Groundwater Transfer Review Summary Form

Transfer/PA # T- 13621

GW Reviewer Joe Kemper Date Review Completed: 5/22/2023

Applicant Name: City of Prineville

Transfer Map

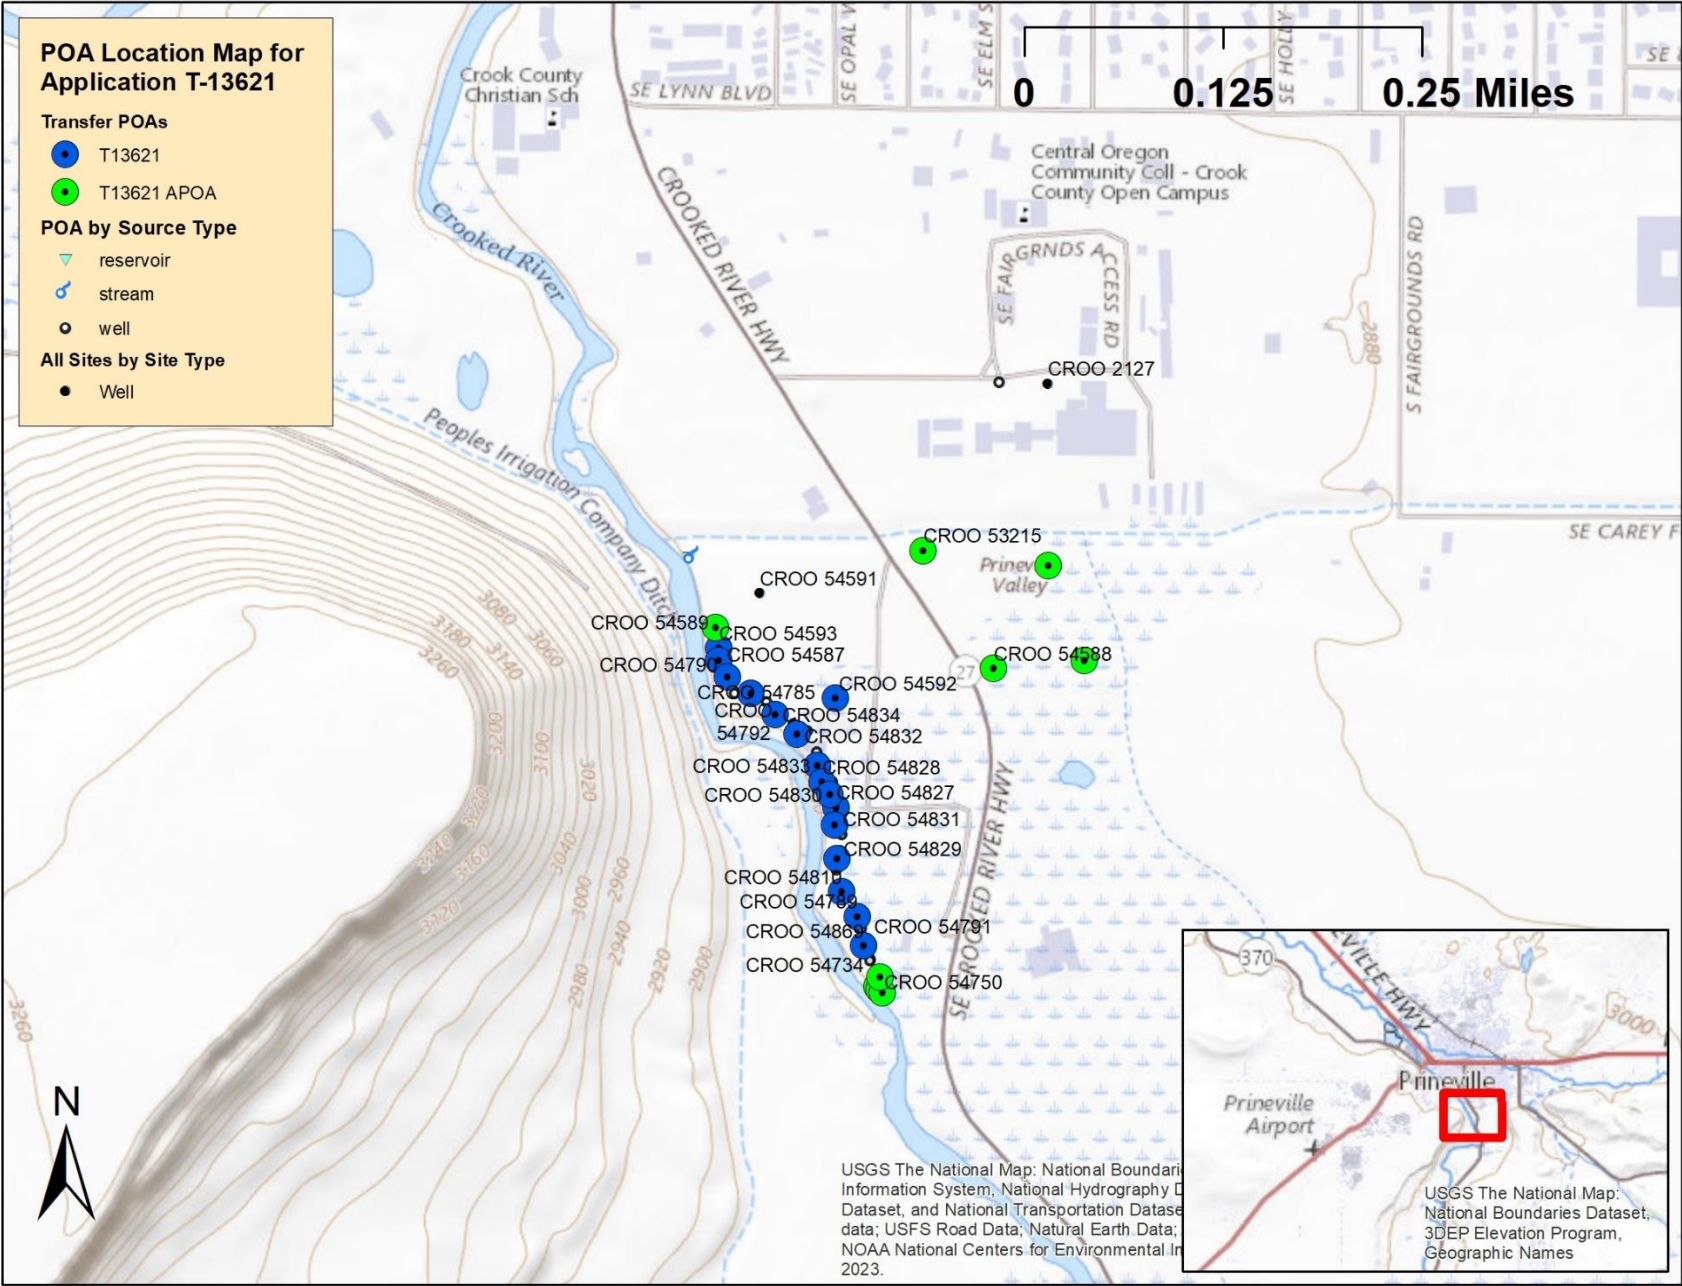
-
1. Basic description of the changes proposed in this transfer: Permit G-18154 allows for 4.46 cfs of municipal use out of 25 POA well field constructed in alluvium immediately adjacent to the Crooked River. This permit amendment would create 9 APOA's (including horizontal infiltration galleries) and would refine the locations and well log correlations for the existing 25 POAs.
 2. Will the proposed POA develop the same aquifer (source) as the existing authorized POA?
☒ Yes ☐ No Comments: All current and proposed POA's produce groundwater hosted by alluvium immediately adjacent to the Crooked River.
 3. a) Is there more than one source developed under the right (e.g., basalt and alluvium)?
☐ Yes ☒ No NA
b) If yes, estimate the portion of the right supplied by each of the sources and describe any limitations that will need to be placed on the proposed change (rate, duty, etc.): NA

4. a) Will this proposed change, at its maximum allowed rate of use, likely result in an increase in interference with **another ground water right**?
☒ Yes ☐ No Comments: The wellfield is intentionally constructed to induce infiltration from the Crooked River. Because the stream acts as a relatively constant head boundary, drawdown in the target aquifer is expected to be minimal. There is one permitted well (CROO 2127 under certificate 48584) approximately 500 feet north of POAs 24-27. Because those wells are ~1000 feet from the river, pumping induced drawdown may be sufficient to create noticeable well-to-well interference.

- b) If yes, would this proposed change, at its maximum allowed rate of use, likely result in another groundwater right not receiving the water to which it is legally entitled?
☐ Yes ☒ No If yes, explain: The Crooked River is still expected to provide sufficient recharge to supply water to the pumping wells. Any well-to-well interference is expected to be minimal and would not meet the definition of injury.

5. a) Will this proposed change, at its maximum allowed rate of use, likely result in an increase in interference with **another surface water source**?
☐ Yes ☒ No Comments: The wellfield under permit G-18154 is intentionally constructed to induce infiltration from the Crooked River; interference with the Crooked River is approximately 100%. Thus, the proposed changes would not reflect an increase in that interference.
